ADDENDUM NO. 3

Date: September 7, 2018
Project: **Secondary Treatment Plant Upgrade & Recycled Water Expansion**
Job No.: 12600-07/16650-02

The following changes and/or clarifications are hereby made to the Contract Documents, and shall become a part of the Contract Documents dated July 2018.

**PROCESS BUILDING
MECHANICAL SECTIONS**

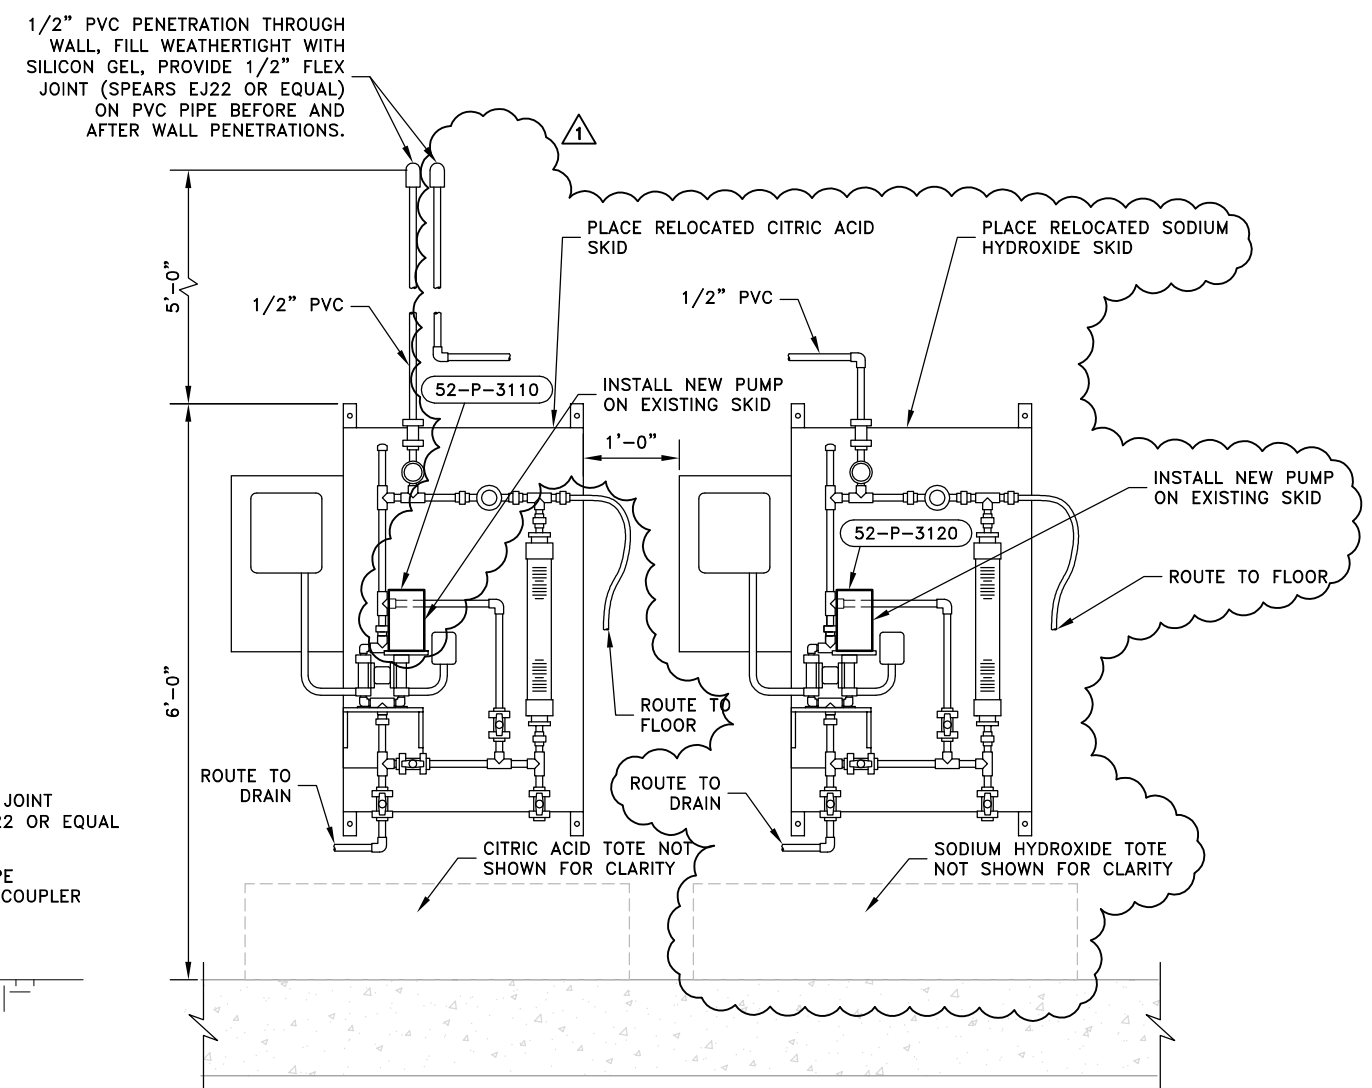
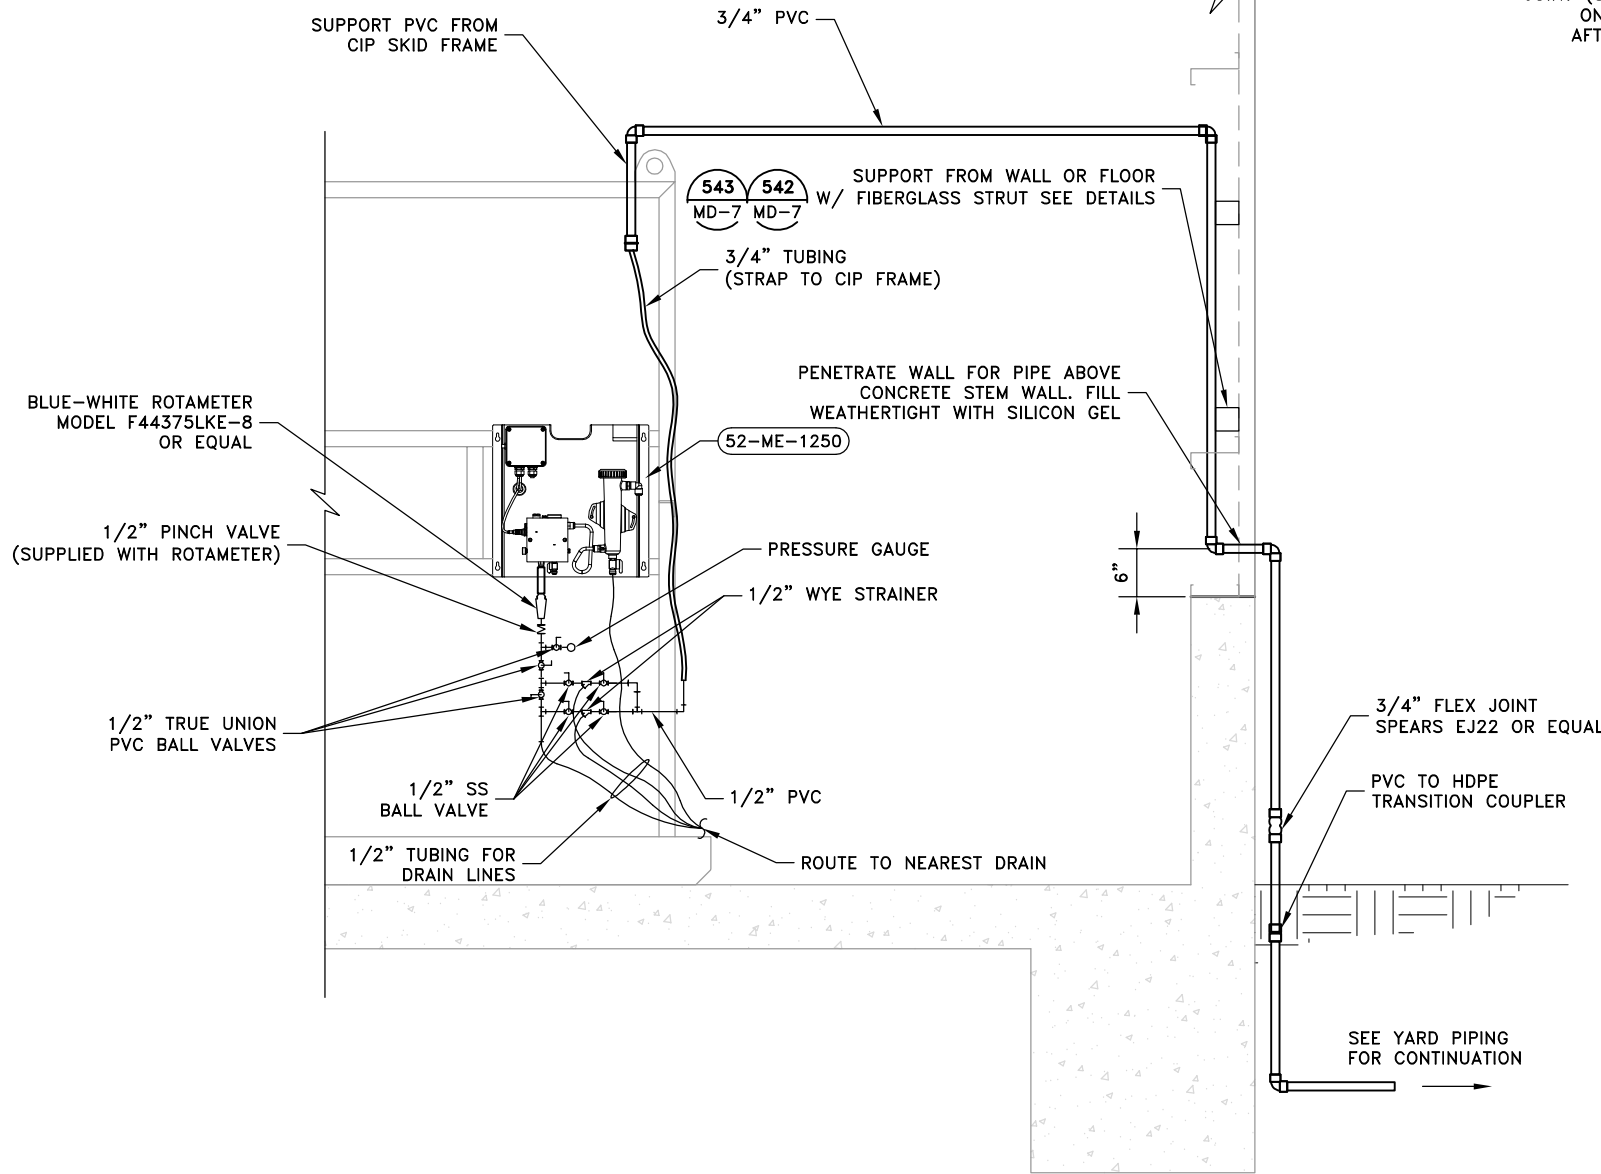
5. **Sheets RMD-2, RM-1 and RM-8:** The following updates are made to the demolition/removal instructions on this sheet:
 - a. Owner now requires two (2) of the chemical process skids to be relocated to the outdoor enclosure rather than one. Thus, two of the three chemical dosing skids (citric acid as already indicated and now sodium hydroxide) are to be removed and relocated to the outdoor awning area, including their associated chemical storage and containment stands. The third skid and its associated chemical storage/containment stand is still to be removed and salvaged to Owner.

- b. Owner has elected to replace the pumps on the two relocated chemical pump skids rather than reusing the pumps. Thus, on the two (2) skids that are to be relocated to the outdoor awning, the chemical pumps on these skids are to be removed and disposed of. New peristaltic pumps, of the same make included elsewhere on the project, are to be installed on these existing pump skids. The third skid that is to just be salvaged to Owner does not require a replacement pump.

The two (2) replacement pumps shall be BlueWhite Model # M-324-TK, 115V. Note that these pumps will also be added to the pump schedule as discussed below in this addendum.

Revised versions of sheets RMD-2, RM-1 and RM-8 are provided with this addendum for reference. Note that other sheets in this area (RMD-1 thru RM-8) will be updated to incorporate these changes for the construction set.

**HYPOCHLORITE PUMP BUILDING
MECHANICAL PLAN**

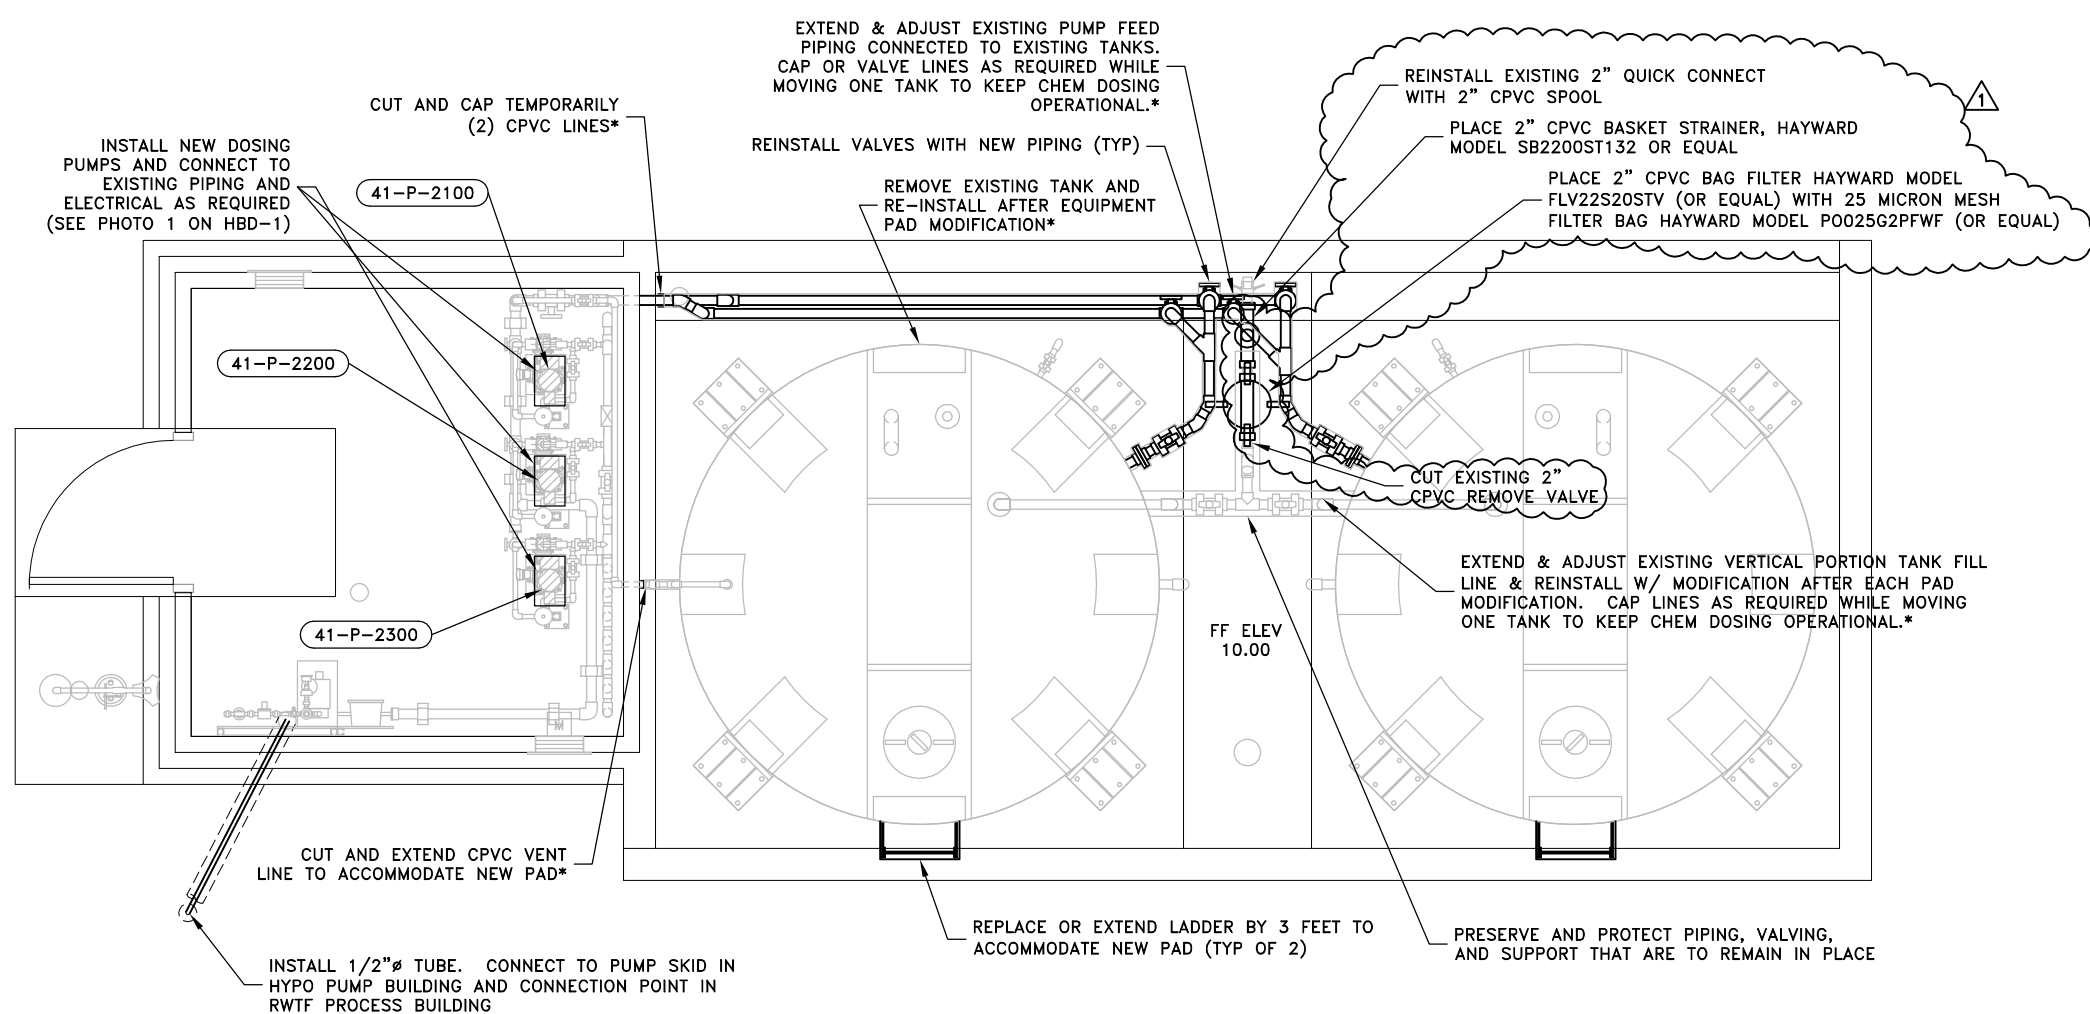
6. **Sheet HBD-1:** The District now requires the contractor to **salvage** the three diaphragm pumps to be removed in this building, rather than disposing of the pumps. Note also that the 2-inch tank fill line will need to be modified (i.e. removed and reinstalled) to accommodate a new basket strainer and bag filter, as described in the changes for sheet HBM-1 below.
7. **Sheet HBM-1:** The design of the chemical fill tank piping (to be adjusted to accommodate raising the tank pads) has been revised to incorporate a basket strainer and a bag filter on the 2-inch fill line with the existing quick connection. These additional filters are required as part of this work. **A revised copy of this sheet is included as an attachment to this addendum.** The design-basis make/model of the basket strainer and bag filter are noted in the revised drawing and stated again here for reference:

- Basket Strainer -Hayward Model SB2200ST132 (2" CPVC basket strainer with 1/32" perforations in CPVC strainer) or equal.
 - Bag Filter – Hayward Model FLV22S20STV (2" CPVC basket strainer with Viton gaskets) or equal.

DECHLORINATION CHEMICAL STORAGE MECHANICAL PLAN

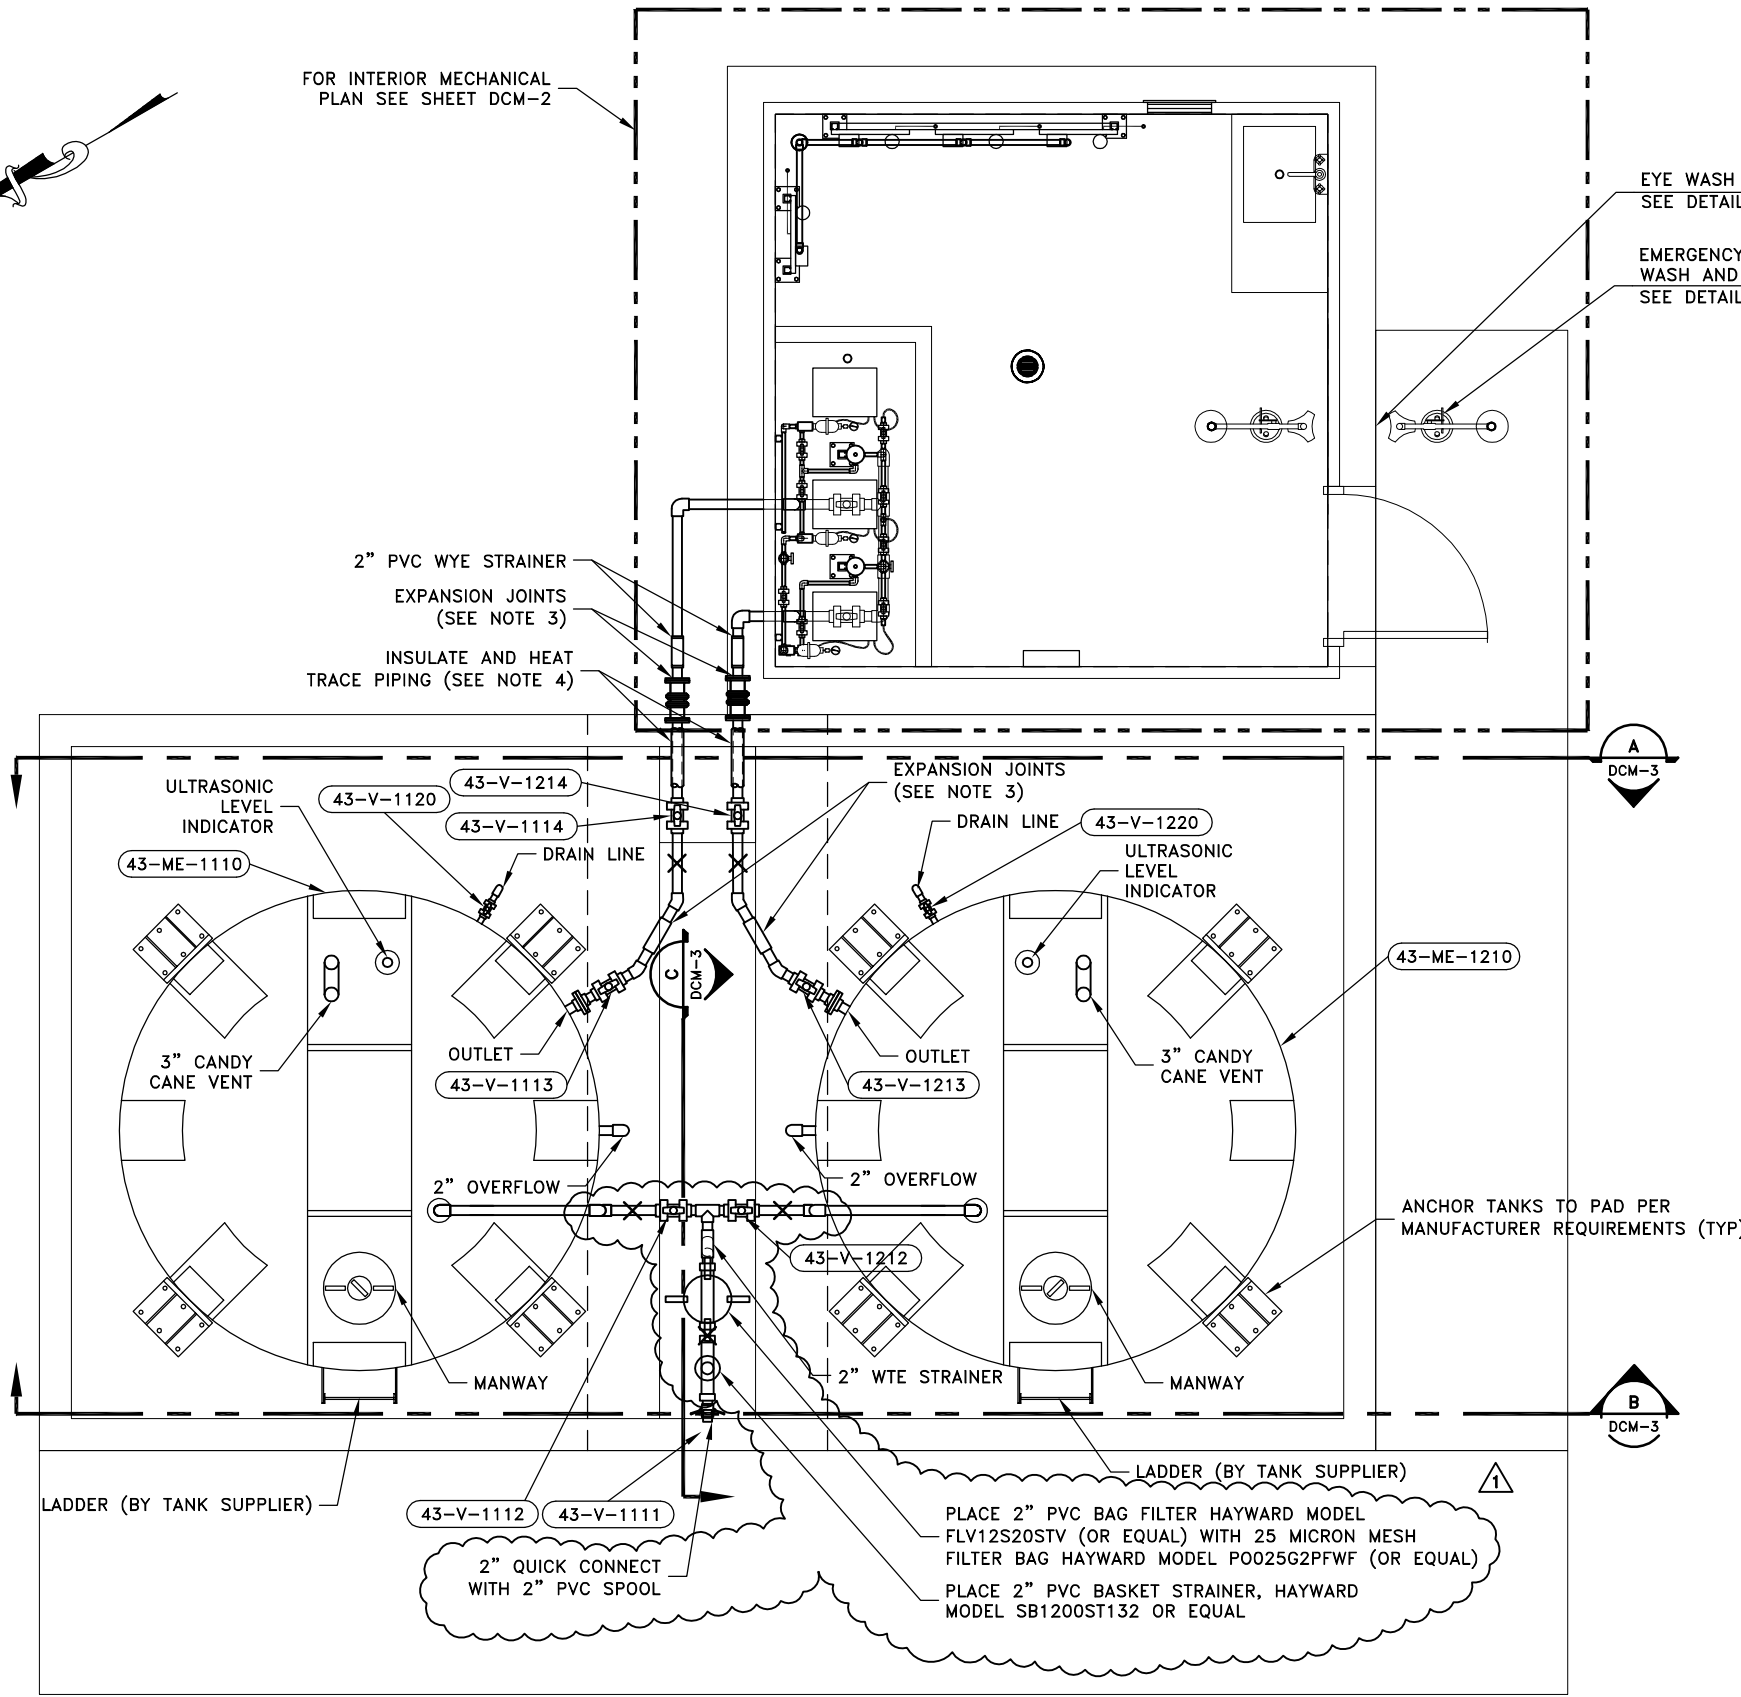
- Bag for Bag Filter: 25 mesh bag model PO025G2PFWF) or equal.
8. **Sheet DCM-1 and DCM-3:** The design of the chemical tank fill line in this area has been revised to incorporate a basket strainer and a bag filter. These additional filters are required as part of this work. The design-basis make/model of the basket strainer and bag filter are noted in the revised drawing and stated again here for reference:

- Basket Strainer -Hayward Model SB1200ST132 (2" PVC basket strainer with 1/32" perforations in CPVC strainer) or equal.
 - Bag Filter – Hayward Model FLV12S20STV (2" PVC basket strainer with Viton gaskets) or equal.

- Bag for Bag Filter: 25 mesh bag model PO025G2PFWF) or equal.
